Project # 25036 (MKM), 2509-276 (Hafer) – EVPL Red Bank Library
New Construction / 120 S. Red Bank Road, Evansville, IN 47712

ADDENDUM No. 2

June 24, 2026

1 ROOF PLAN
1/8" = 1'-0"

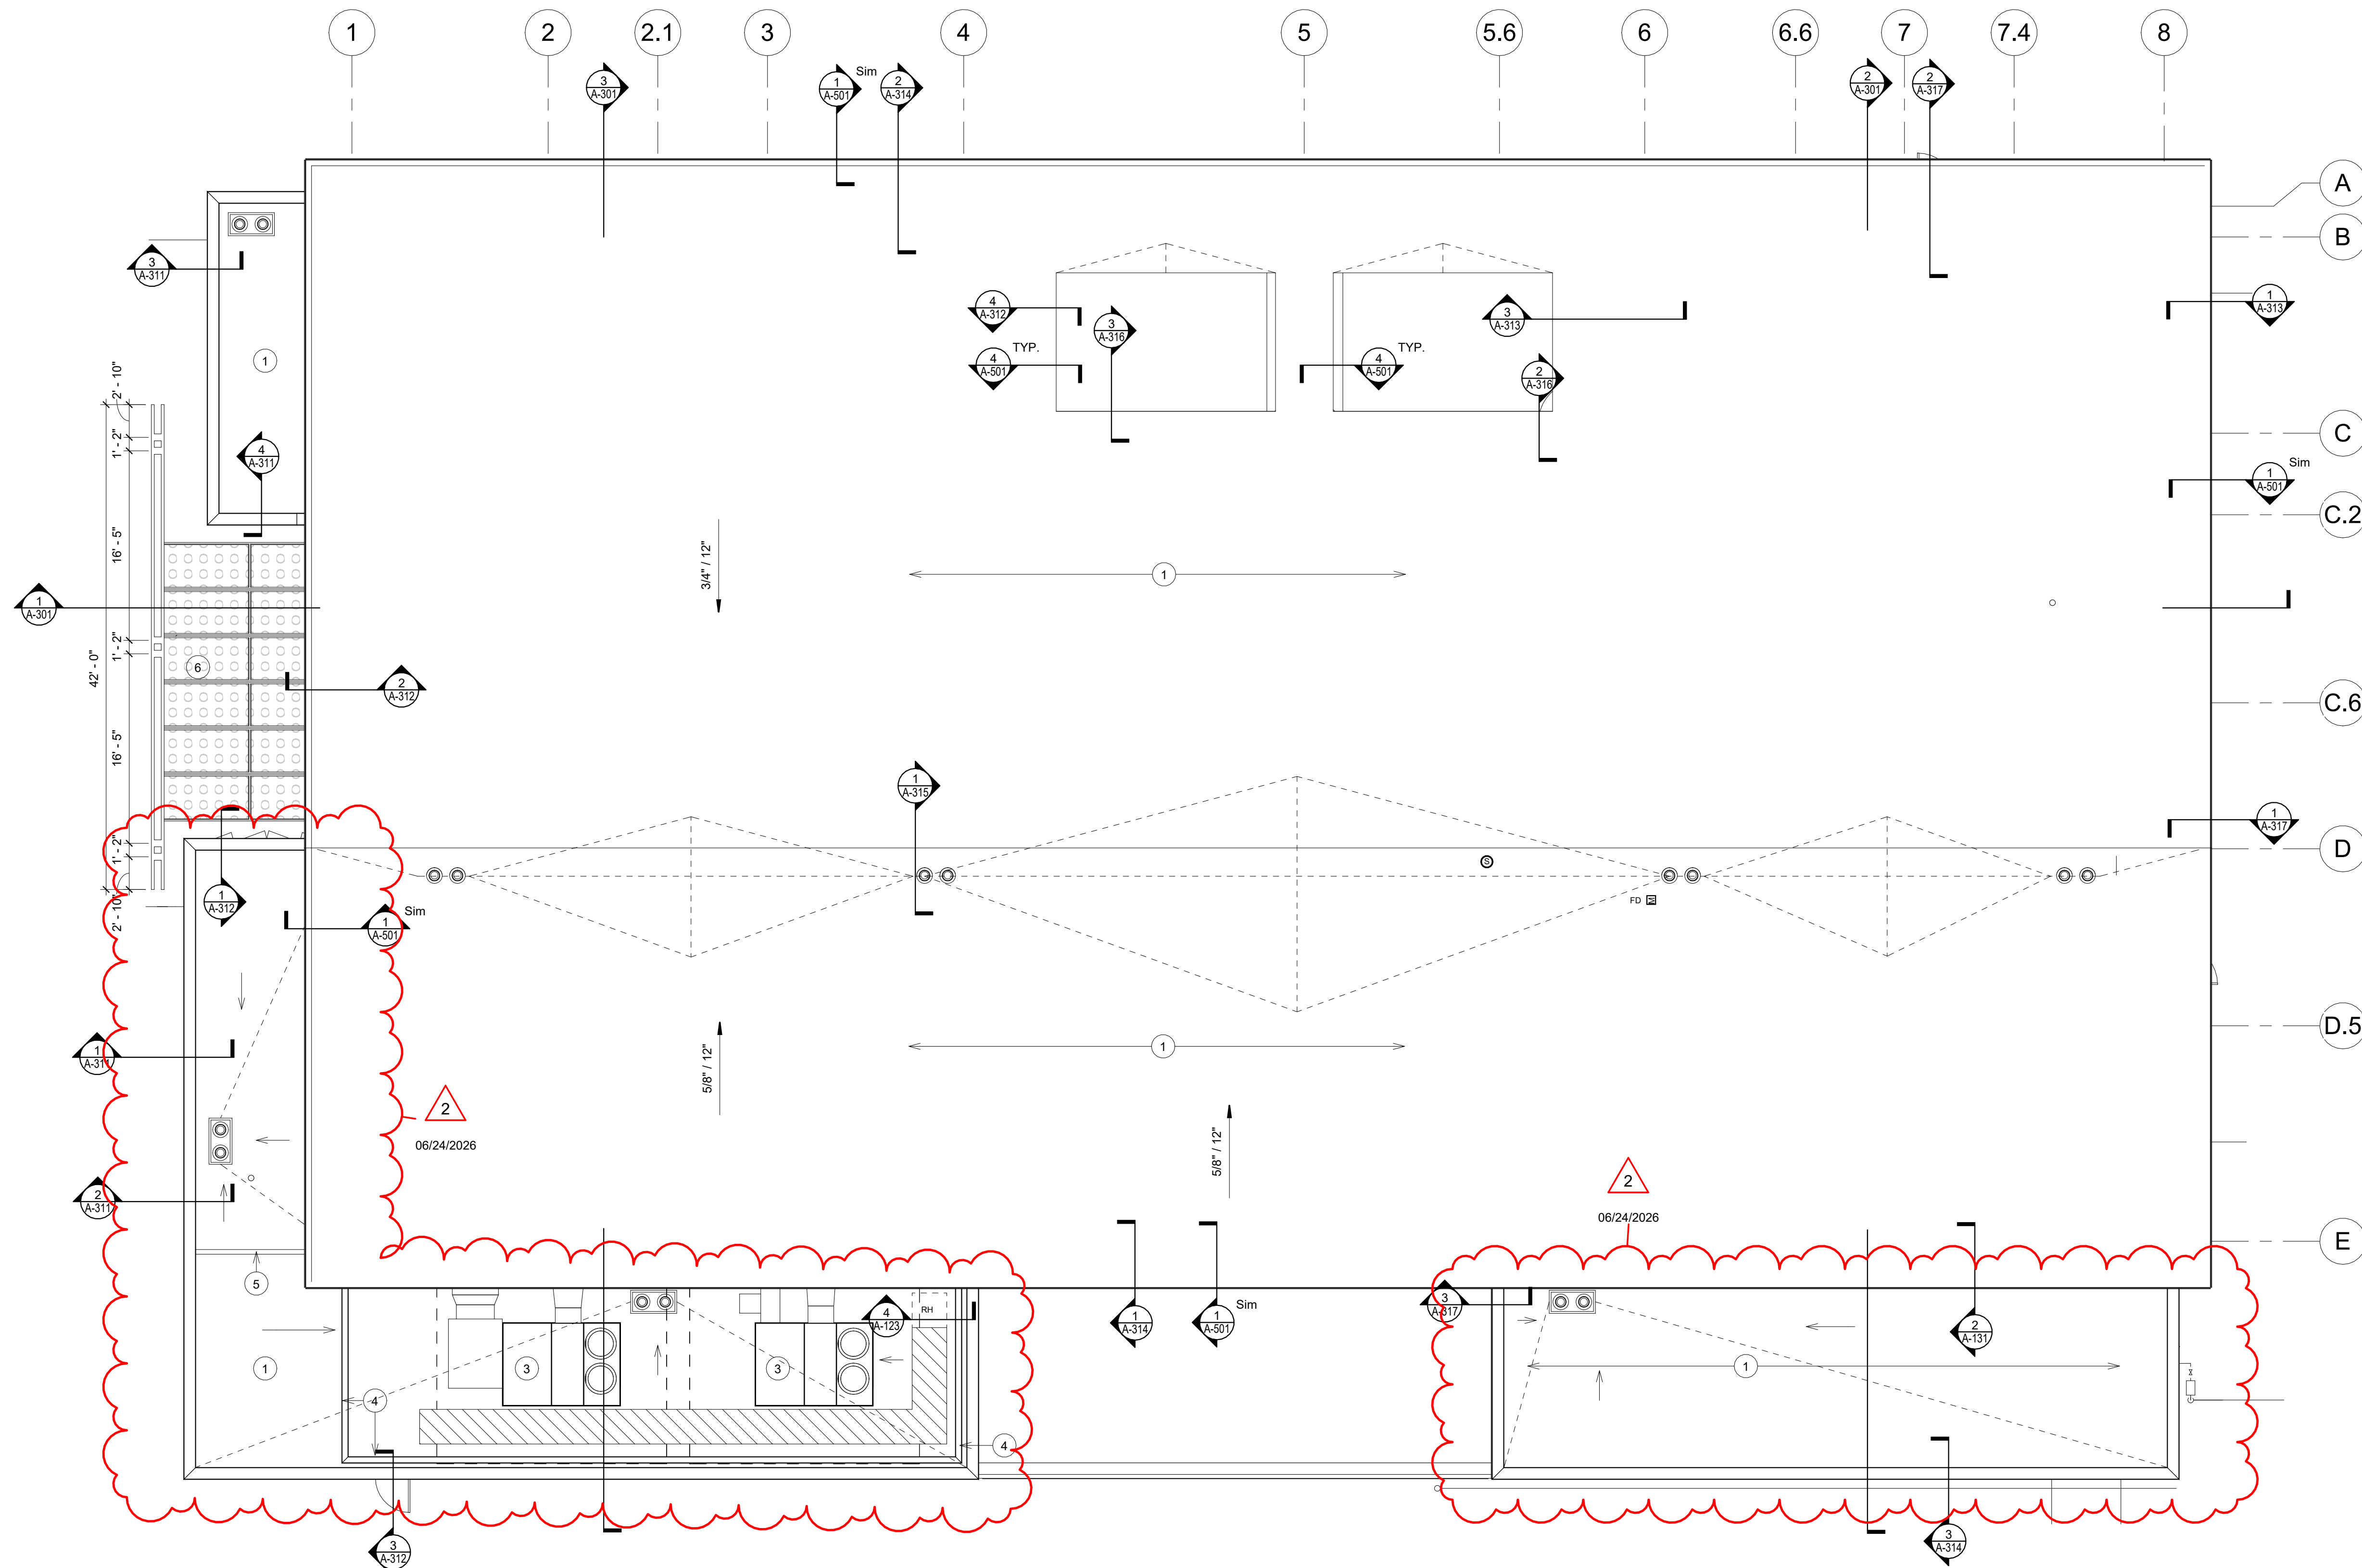
- vv. Answer: Sound attenuation batt insulation is not required within the flutes of the deck.
- ww. Question: There is a roof section on A123 next to the screen wall on the southside of the building that does not show any drains or a detail for the outside edge. Does this get drains or gutters?

a. **Sheet A-123 – ROOF PLANS & DETAILS**

- i. Addition: tapered insulation lines added leading to roof drains on the lower roofs.

- xx. Answer: The section is not intended to be divided from the south section of the roof. The vented metal equipment screen panel will sit on standoffs that allow water to drain through.

1 STEEL LINTEL SCHEDULE
SCALE: 1" = 1'-0"

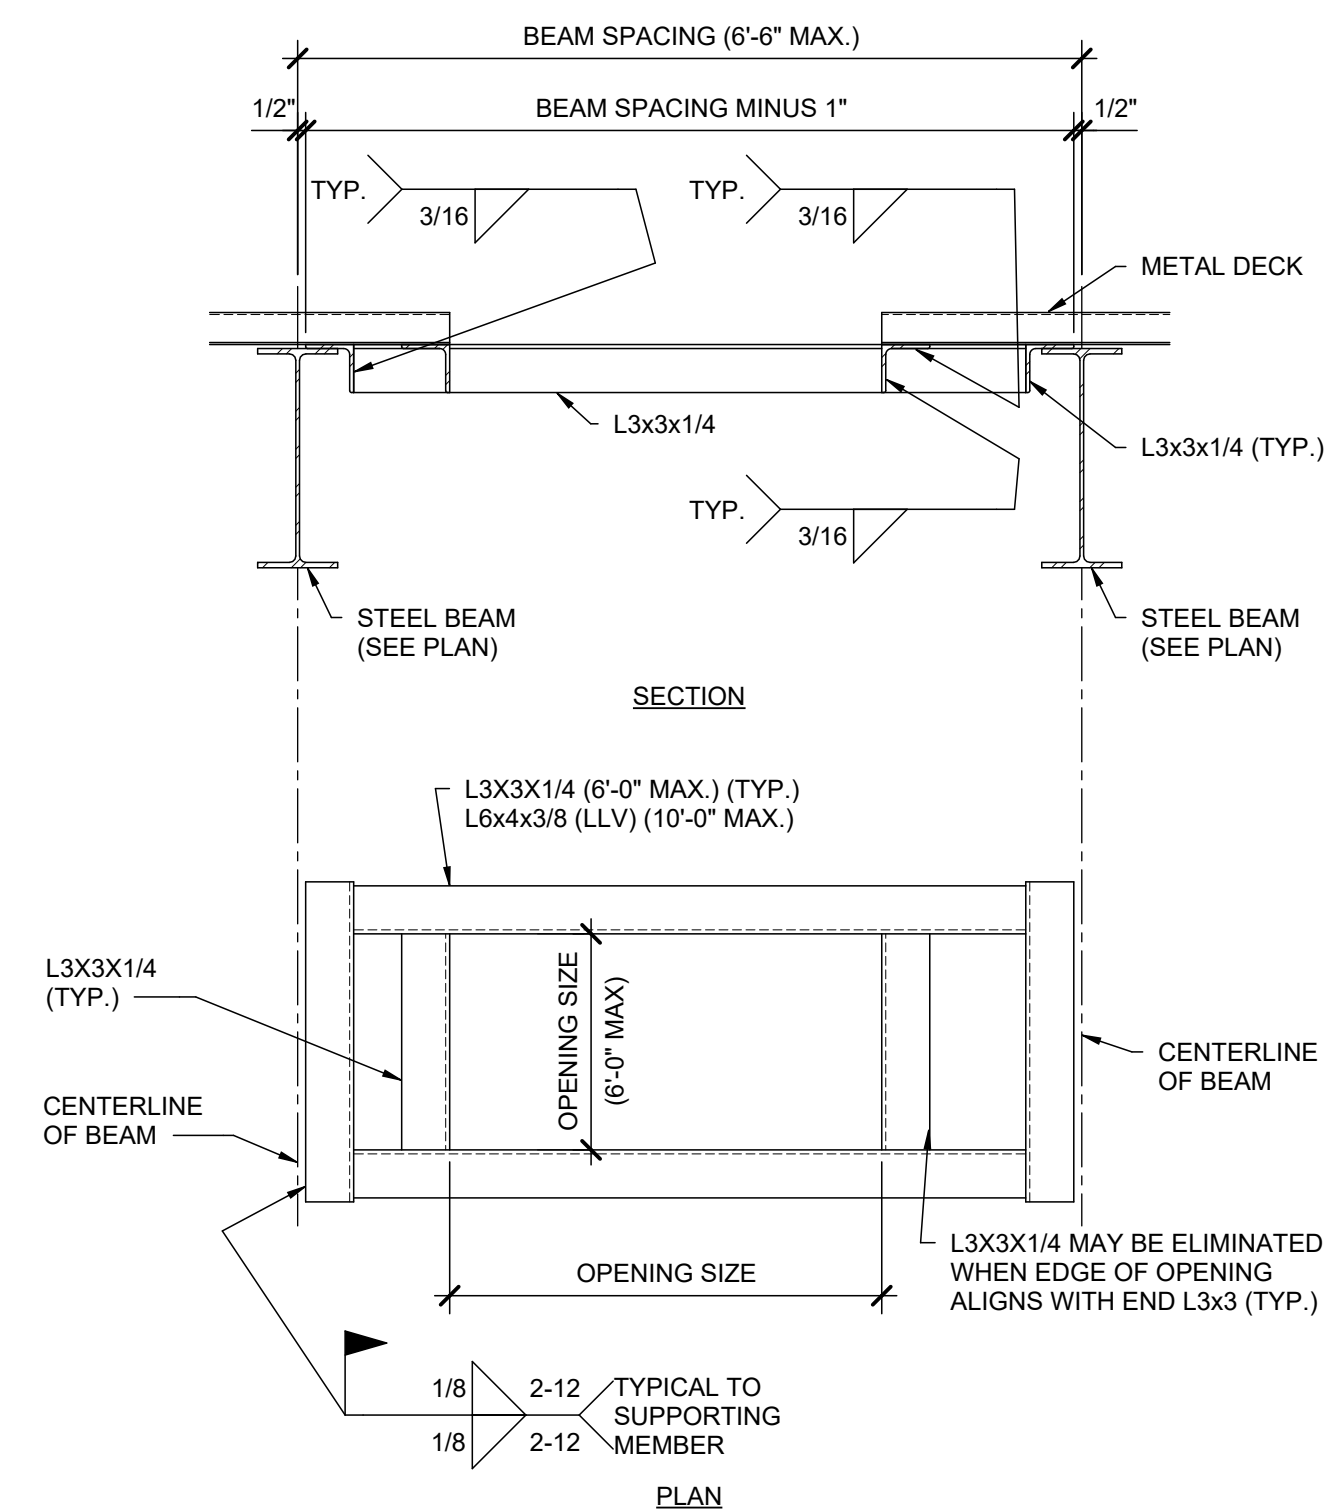
- n. Answer: Missing details for the deck and railing are forthcoming via Addendum 3.
- o. Question: Please confirm whether any loose steel lintels are required for this project. If lintels are required, please provide the locations and corresponding lintel types to be installed, or identify the applicable drawings/details where the lintels are designated.

- p. Answer: Steel lintel schedule on sheet S-002 was deleted. See Sheet S-105 for additional information and locations regarding CMU lintels within the project. Additional details to be provided in Addendum 3).

DRAWING CONTENTS:
LOWER LEVEL
FOUNDATION PLAN

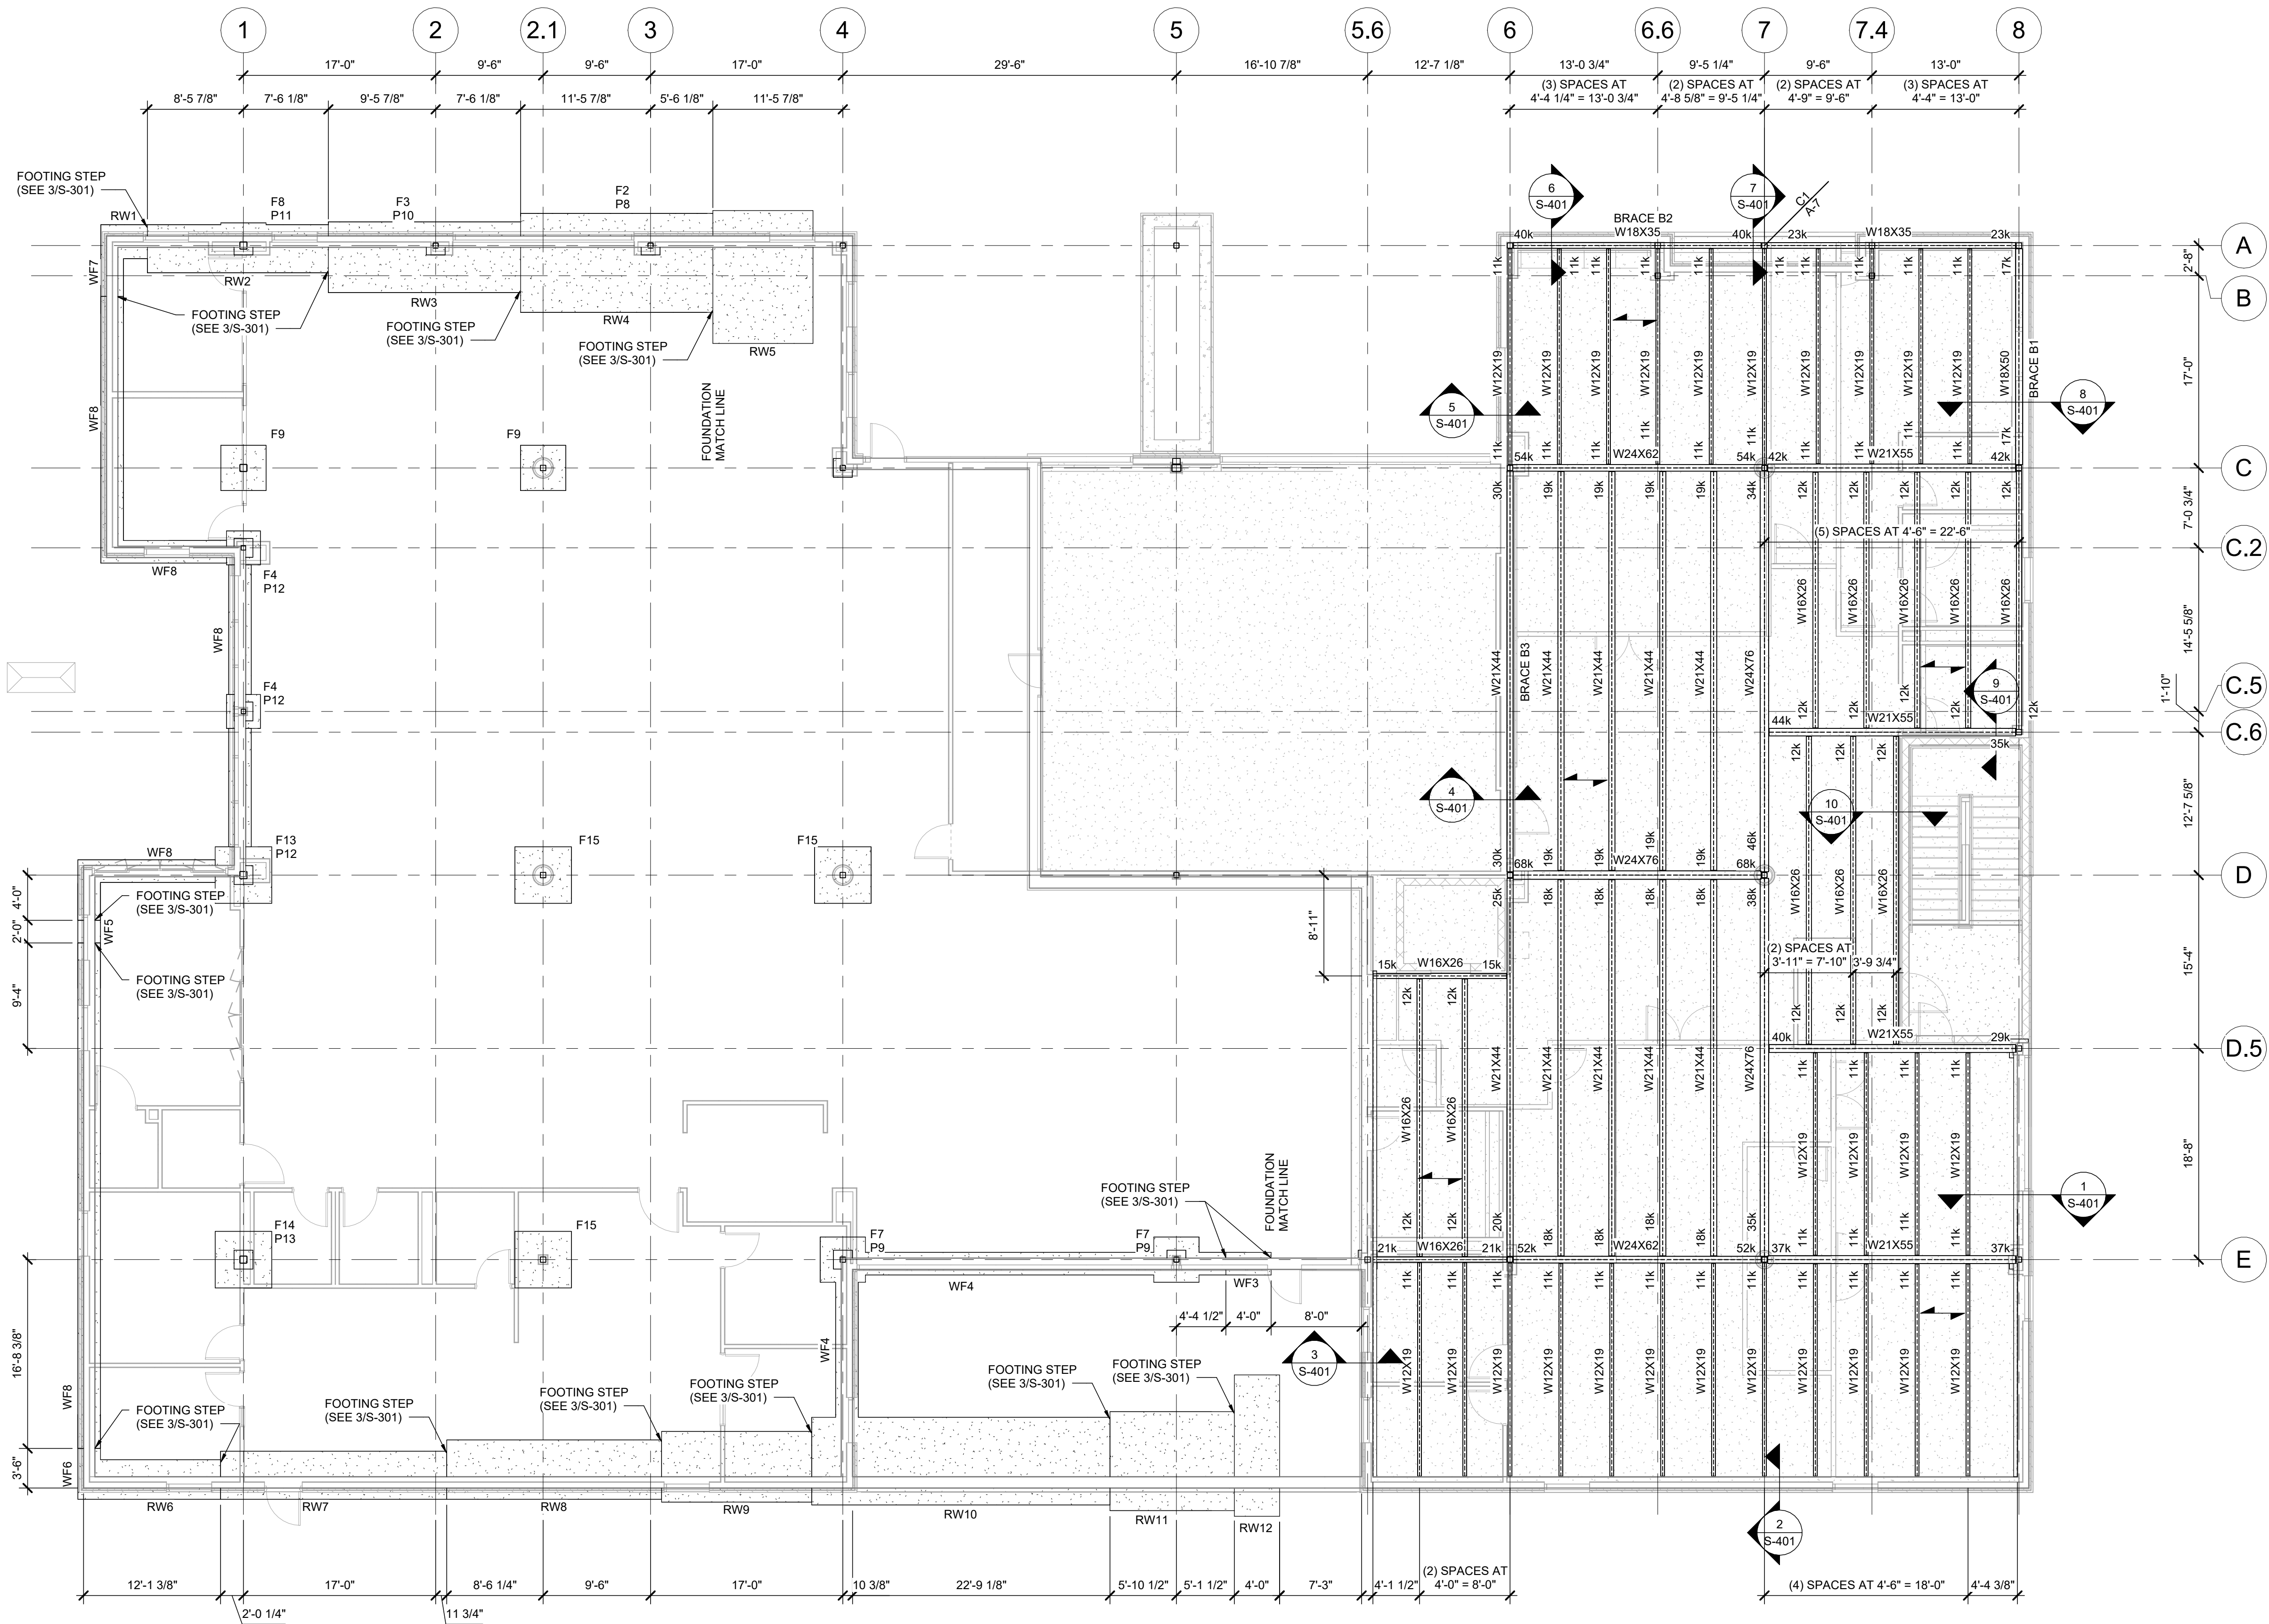
- jj. Answer: Johnsonite Millwork wall base to be installed on circular column covers.
- kk. Question: Please provide heel and toe pressures for the retaining wall and combined foundations – required for aggregate piers.

c. **Sheet S-101 – LOWER LEVEL FOUNDATION PLAN**

- i. Clarification: Revised Foundation Plan Note #10
- ii. Addition: Added Foundation Plan Note #12
- iii. Addition: Added Footing Loads Schedule.

- ll. Answer: For the retaining walls, see plan note 11 on sheets S-101 and S-102. That provides guidance on the wall and retaining wall footings for rammed aggregate piers.
